### ADDENDUM NO. 1

RE: Safe Routes to School - Sidewalk 27 Road IFB-5428-24-DD

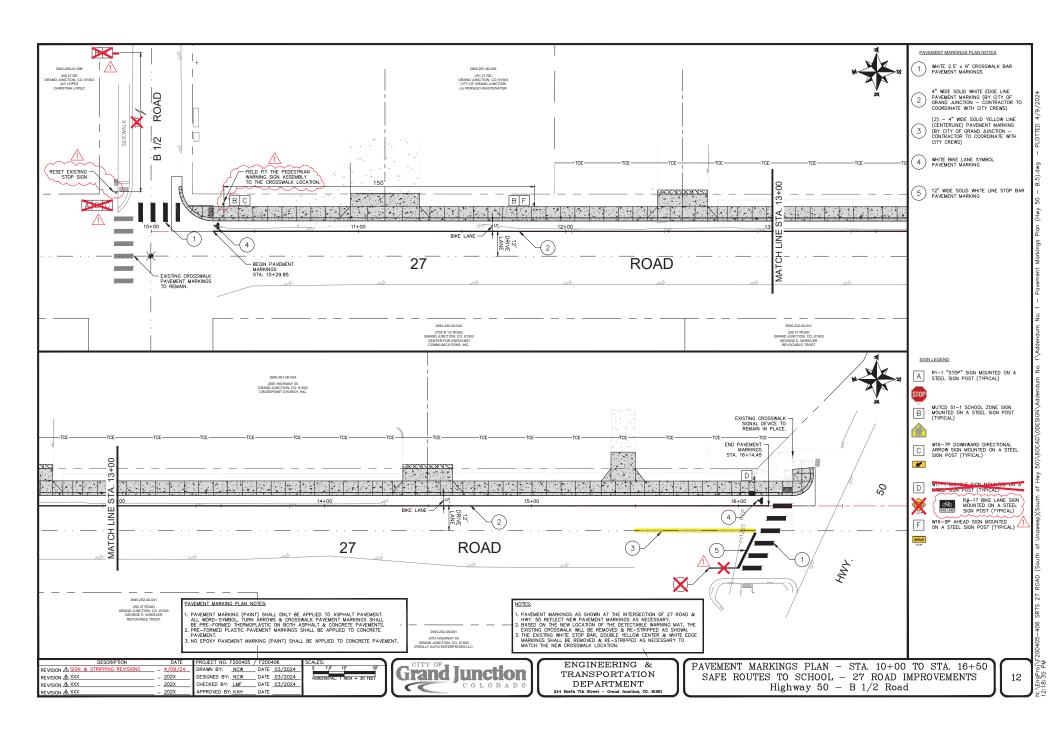
- Revised Pavement Markings Plan (Hwy 50 B ½ Rd) (age 12 of Plan Set
- Revised Pavement Markings Plan (Unaweep B ¾ Rd) Page 21 of Plan Set
- Revised Pavement Markings Plan (Unaweep B ¾ Rd) Page 22 of Plan Set
- Revised Bid Schedule \*\*This must be used for submitting your bid\*\*
